5 August 2019

## **SECTION 4.55(1A) MODIFICATION APPLICATION TO SSD 16\_7919 - RESPONSE TO RFI 85 CARABELLA STREET, KIRRIBILLI**

**Figure 1** Location of bicycle parking and access from Elamang Avenue  
Source: FJMT

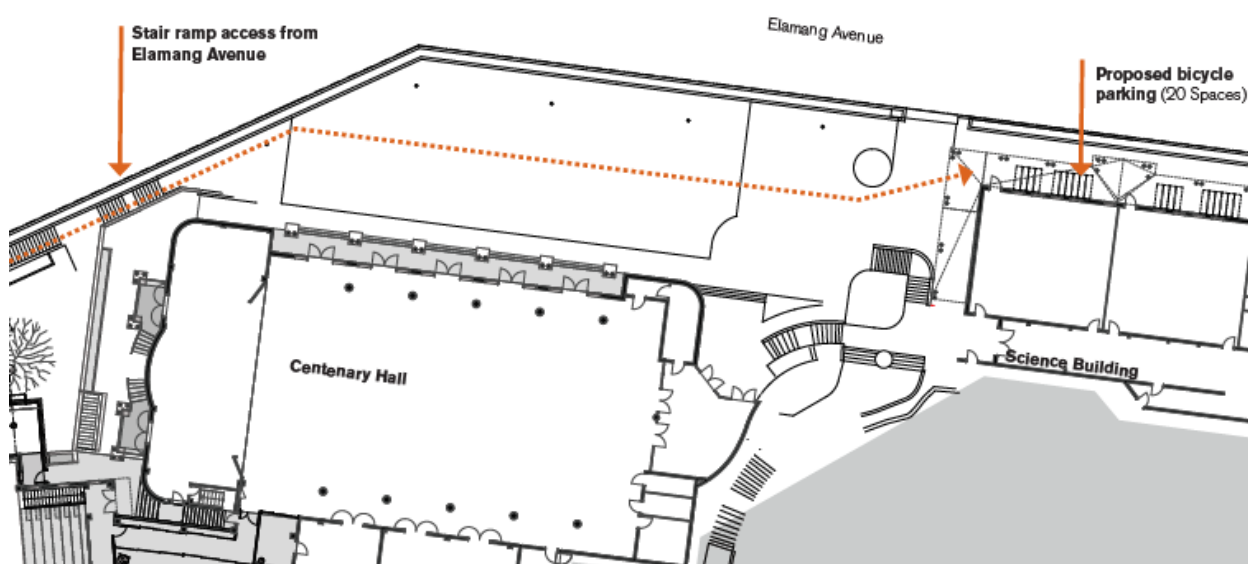
*Please specify the location of the bicycle parking area and the accessible entry to the bicycle parking from Elamang Avenue. This was a requirement of the conditions of consent.*

Consistent with the approved development, 20 bicycle parking spaces will be provided under the Science Building, with end of trip facilities to be provided in the western precinct redevelopment. The proposed bicycle parking is shown on the **attached** diagrams and at **Figure 1**. Access will continue to be provided via a ramp from Elamang Avenue. The end of trip facilities are provided as part of the western precinct redevelopment and are shown on DA-2201 and **Figure 2**.

**Figure 3** Approved and proposed location of the movement and weights studio  
Source: FJMT

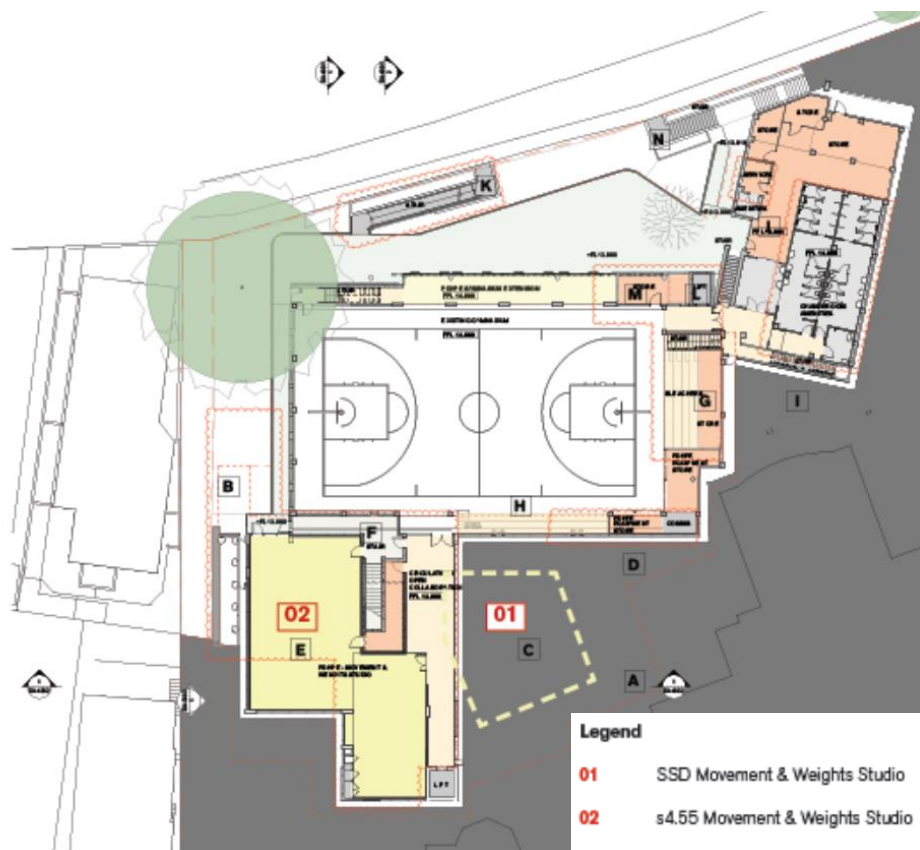
- *Whether the change in materials and the change in plan, especially the lower ground floor which now includes a huge area with no ventilation (PDHPE and weights), lead to any alterations to the ESD targets. While the design report states that the skylights would ventilate this, this is not a practical solution as no one will operate the skylights in the school on a daily basis and the new design of this floor completely eliminates natural light and ventilation which was previously provided (the glazed door and window are less than 1% of the floor area and not considered sufficient for this purpose).*

As shown in **Figure 3**, in the SSD submission natural daylight and ventilation was not able to be provided in the movements and weights studio as a result of the disconnect with the external environment. The function of the revised weights area is divided into two zones - the zone to the south-east will have a raised acoustic floor to accommodate free weights and a sled track, the zone to the west will accommodate cardio equipment such as ergonometres for rowing training, exercise equipment such as running machines, cycles and steppers and a central circuit area. Not unlike a commercial weights gym, daylight is not essential for the function of this area. However, daylight has been provided via two large skylights and the northern glazed wall and door, which will improve the daylight condition when compared to the original SSD application, where there was no access to natural light or ventilation. A comparison between the approved and proposed location of the weights area and gym is provided at **Figure 3**.

The two skylights have been incorporated into the design to provide a connection with the environment, as will the glazing to the north. The function of the skylights is for daylight and not natural ventilation. An indicative view of the proposed weights area is **attached** and provided at **Figure 4**.
